Form 3160-5 UNITED STATES (August 1999) DEPARTMENT OF THE AND MANAGEMENT				FORM APPROVED OMB NO. 1004-0135 Expires: November 30, 2000 5. Lease Serial No.	
SUNDRY NOTICE	L AND REPORTS	MENTE VEI	√LU	1	
Do not use this foliation abandoned well. Use Fo	r proposals to drill or	r tố Te-enter an	PM 1: 15	6. If Indian, A	1 Allottee or Tribe Name
SUBMIT IN TRIPLICATE, Other instructions on reverse side ington, NM				7. If Unit or	CA/Agreement, Name and/or No

1. Type of Well Oil Well X Gas Well Other				8. Well Name	e and No.
2. Name of Operator ConocoPhillips Company				SJ 31-6 U	
		3b. Phone No. (include area code)		9. API Well No. 30-039-27467	
5525 Highway 64, NBU 3004, Farming		505-599-3454			Pool, or Exploratory Area

BLOWOUT PREVENTER ARRANGEMENT & PROGRAM

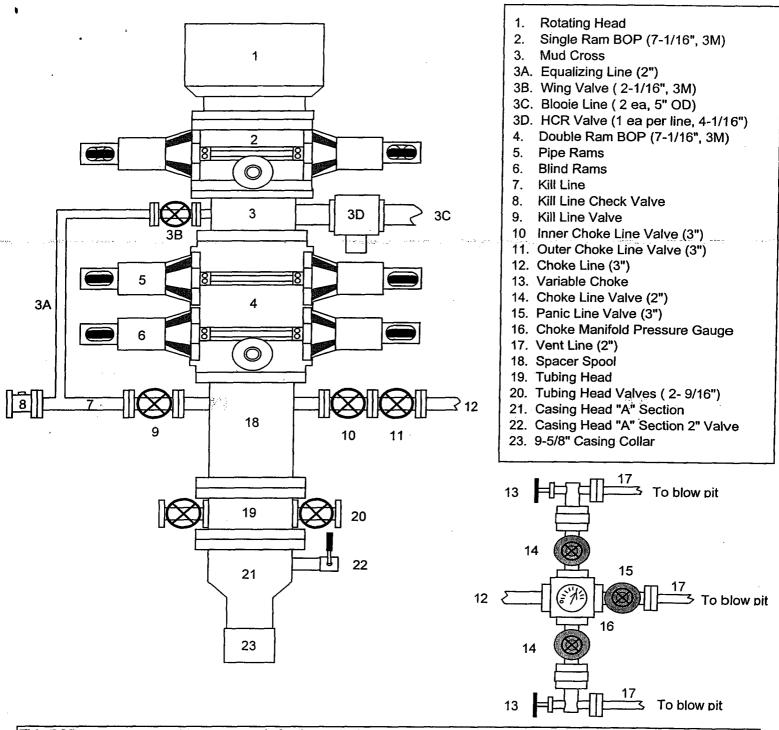
This BOP arrangement is for the drilling operations from the time the 9-5/8" surface casing is set through the setting of the 7" intermediate casing. The Casing Head "A" Section will be screwed onto the 9-5/8" surface casing stub. The BOP will be installed on the Casing Head "A" Section. The Pipe Rams, Blind Rams, Choke Manifold, and 9-5/8" surface casing will be tested to a low pressure test of 200 psi to 300 psi and to a high pressure test of 1000 psi (this value is 44% of the minimum internal yield pressure of the 9-5/8" casing). We will drill the 8-3/4" hole to intermediate casing point and run and cement the 7" intermediate casing. Then we will nipple down the BOP, install a trash cap, & move out the drilling rig. We will install the casing spool on the 7" stub after the drilling rig is moved off location. At a later date we will move in the cavitation rig for the cavitation program.

In addition to the equipment in the above diagram the following equipment will comprise the BOP system:

- 1. Upper Kelly cock Valve with handle
- 2. Stab-in TIW valve for all drillstrings in use
